FINAL DECISION DOCUMENT
FOR THE
GROUND-WATER INTERCEPT AND TREATMENT
SYSTEM NORTH OF ROCKY MOUNTAIN ARSENAL
INTERIM RESPONSE ACTION

July 1989

Prepared for:
U.S. ARMY PROGRAM MANAGER'S OFFICE FOR
ROCKY MOUNTAIN ARESENAL CONTAMINATION CLEANUP

Figure 1-2
IRA STUDY AREA

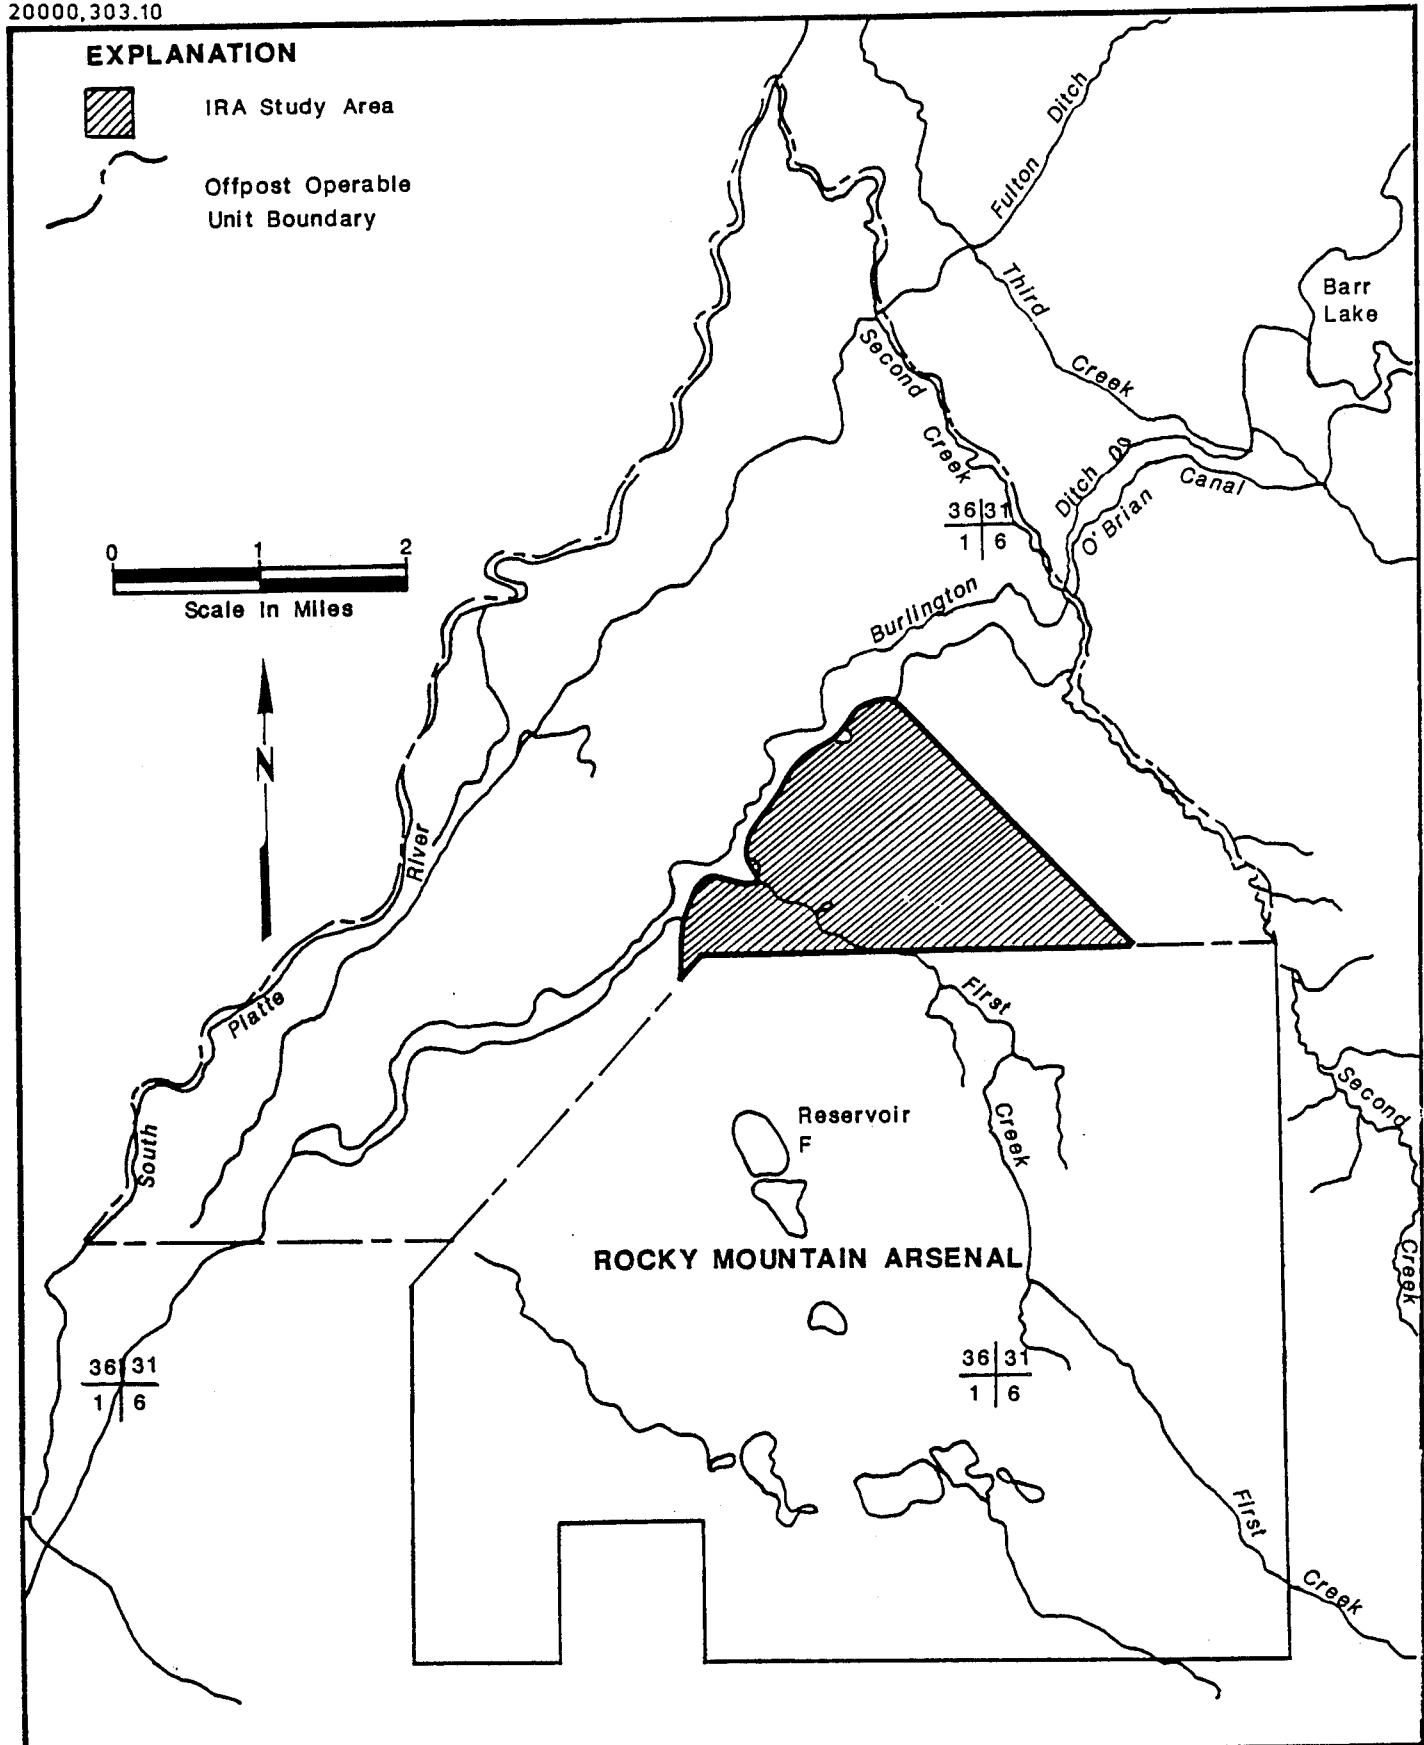
2. Pp. 2-3 and Figure 1-2. The study area is too restrictive to meet all of the objectives of this interim action. The State concurs that the groundwater intercept and treatment systems should be sited within the bounds of the proposed study area. However, RMA contaminants are known to exist in the groundwater as far north as the South Platte River. Therefore, the study area must be expanded to include all off-post areas which may require alternate water supplies and/or monitoring.

Pp. 2-3 and Figure 1-2. The study area is too restrictive to meet all of the objectives of this interim action. The State concurs that the groundwater intercept and treatment systems should be sited within the bounds of the proposed study area. However, RMA contaminants are known to exist in the ground water as far north as the South Platte River. Therefore, the study area must be expanded to include all off-post areas which may require alternate water supplies and/or monitoring.

The study area shown defines the area within which the ground-water intercept and recharge system will likely be located. The need for alternative water supplies over a broader area is being reviewed in the Offpost EA/FS. The document has been revised to indicate the current alternative water supply program, outside the scope of this IRA, will be continued and an alternative water supply will be provided immediately if a well is found to contain RMA-derived contaminants above established health criteria.

Figure 2-2
UNSATURATED ALLUVIUM AND PRIMARY
FLOW PATHS IN VICINITY OF IRA
STUDY AREA

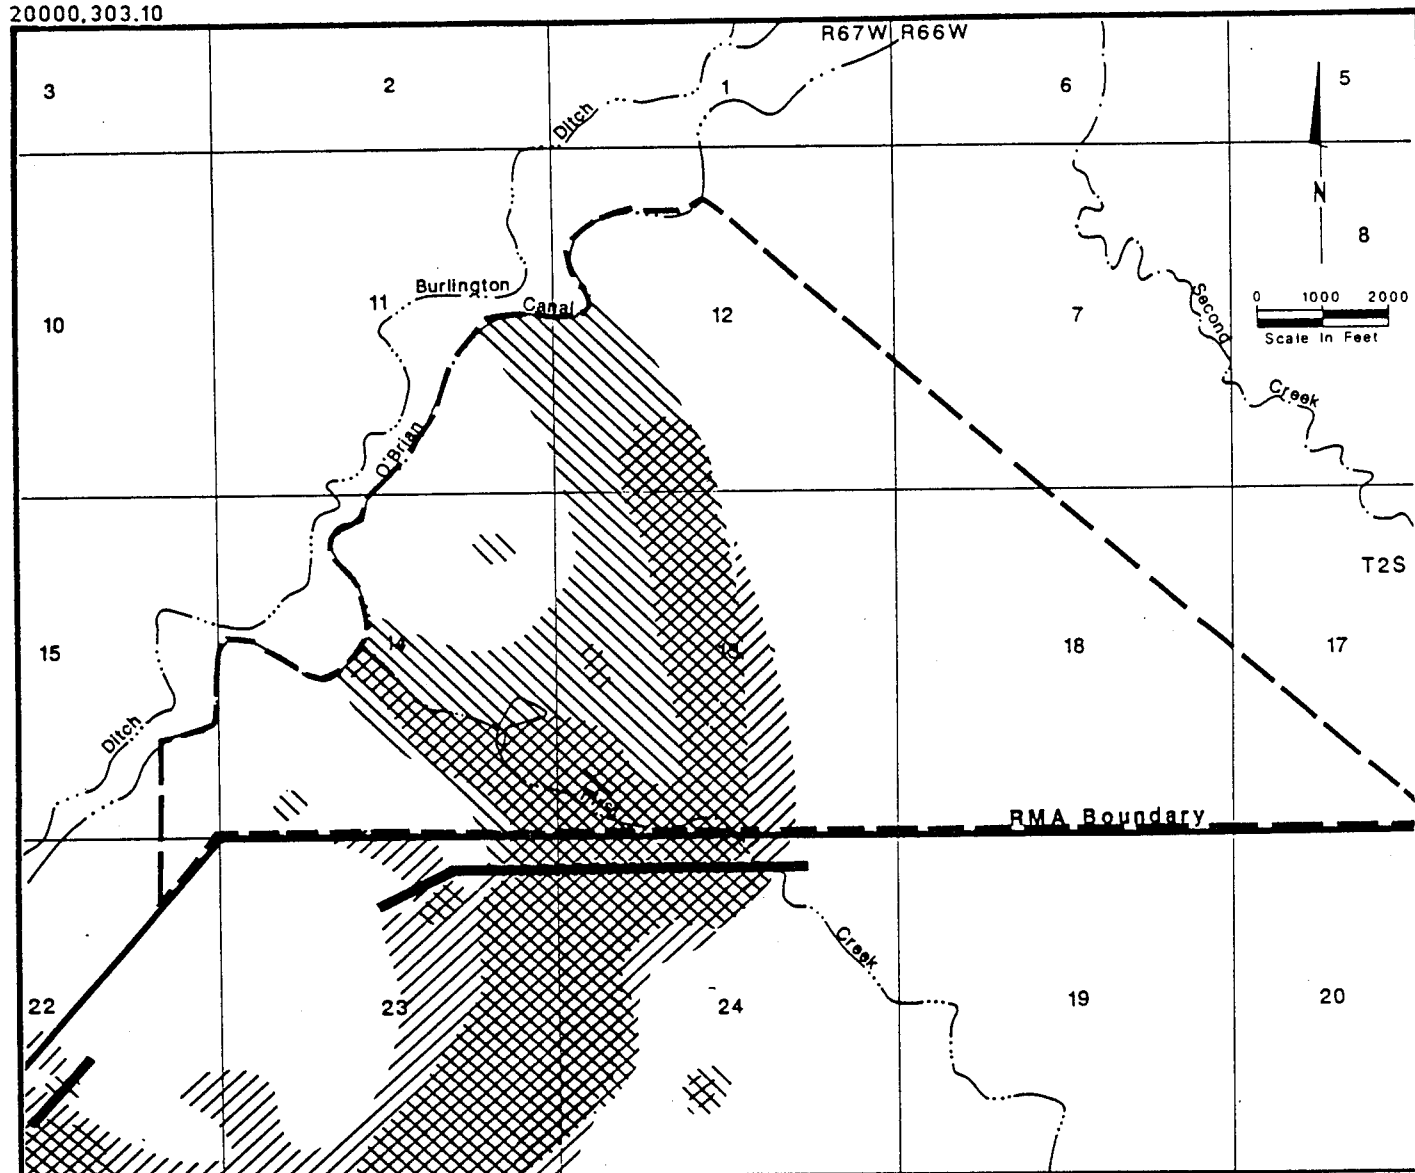
The primary groundwater flow path towards the North Boundary Containment System does not go through Section 23 as implied by the location of the arrow on the Figure. A much larger groundwater flow migrates towards the boundary system through Section 24, near First Creek.

The primary groundwater flow path towards the North Boundary Containment System does not go through Section 23 as implied by the location of the arrow on the figure. A much larger groundwater flow migrates towards the boundary system through Section 24, near First Creek.

The primary groundwater flow path towards the North Boundary Containment System does not go through Section 23 as implied by the location of the arrow on the figure. A much larger groundwater flow migrates towards the boundary system through Section 24, near First Creek.

The figure has been modified in response to this comment.
